**BEFORE THE BOARD OF PATENT APPEALS
AND INTERFERENCES**

Application Number: 09/885,942
Filing Date: June 22, 2001
Appellants: WATANABE ET AL.

EXAMINER'S ANSWER

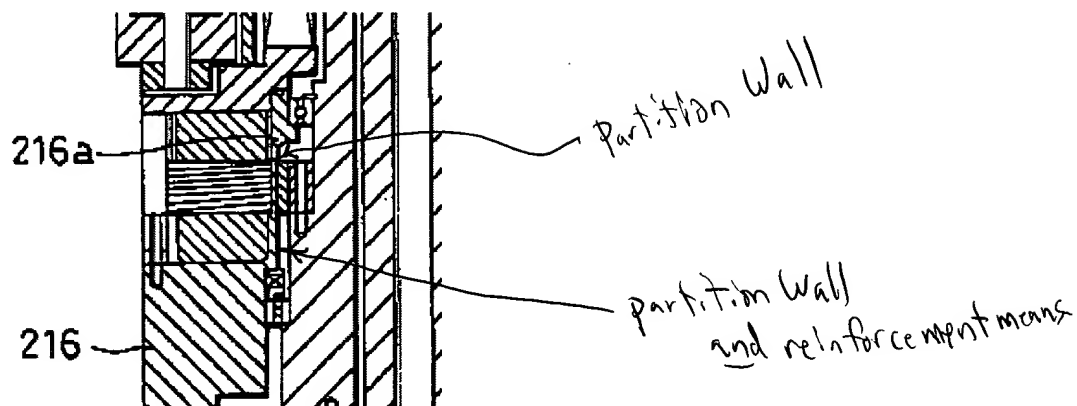
The Applicant's argument regarding the AAPA is not persuasive. AAPA figure 7 shows the bearings mounted directly on the housing 216 and 216a having bearings mounted directly thereon and having a sealing partition extending therebetween. The Applicant's argument regarding the reinforcement means and the force acting on the partition wall between the rotor and stator are not persuasive because the limitations have not been recited as part of the claimed invention. AAPA clearly shows the bearings mounted directly on the housing on opposite side sides of the seal between the stator laminations and the rotor, as set forth in the claims.

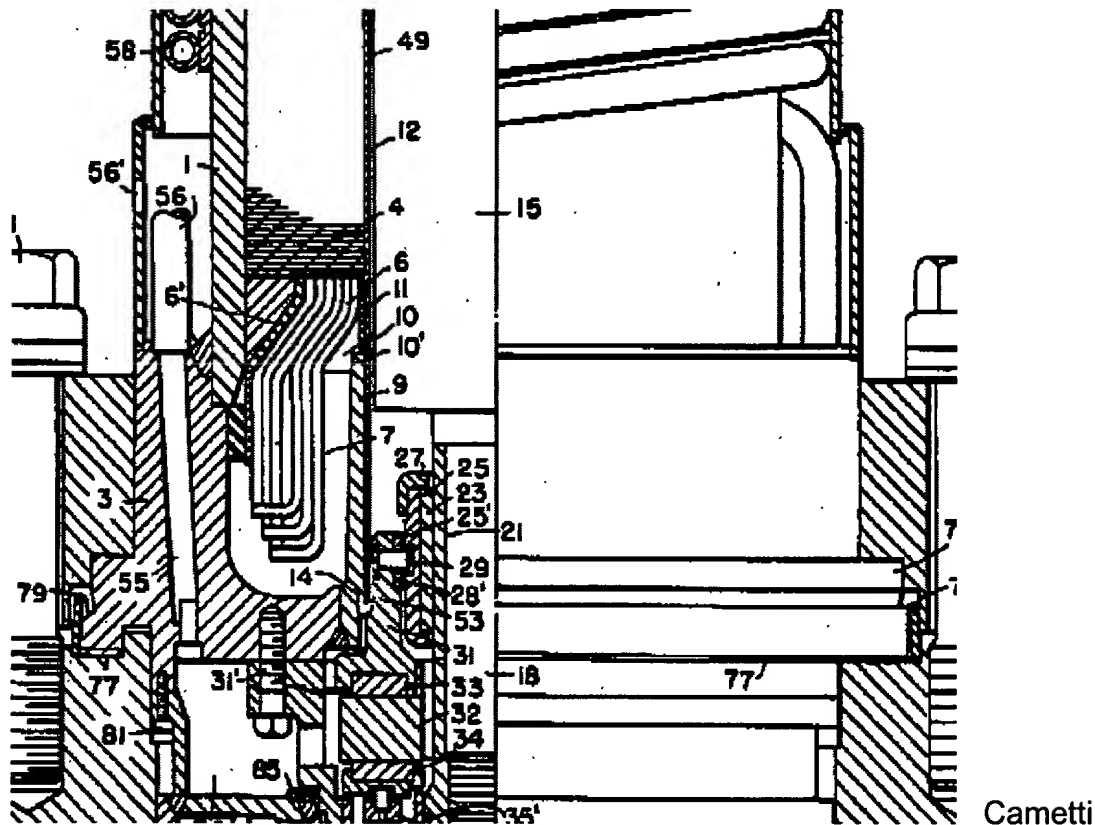
The Applicant's argument that AAPA and Cametti and Hofmeister fail to teach the partition wall between the reinforcing means and the motor rotor is not persuasive. The reinforcement means shown above (figure 7 of the AAPA), shows the partition wall expanding when exiting the air gap between the stator and the rotor. This expanded portion is a reinforcement means is integrally formed with the partition wall and the housing. The partition wall is the inner radial surface of this portion of the housing, such that it is between the rotor (the rotational part of the motor which includes the shaft) and the reinforcement means. Additionally, Cametti teaches the partition wall 12 between

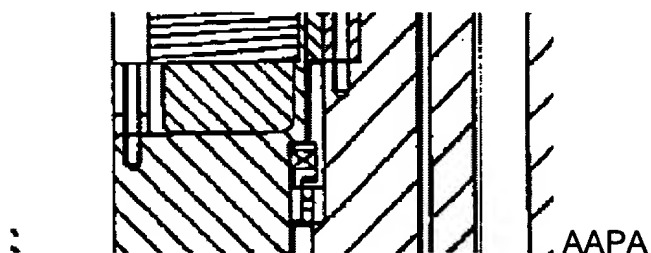
the support 9 and the rotor 15 (See below).
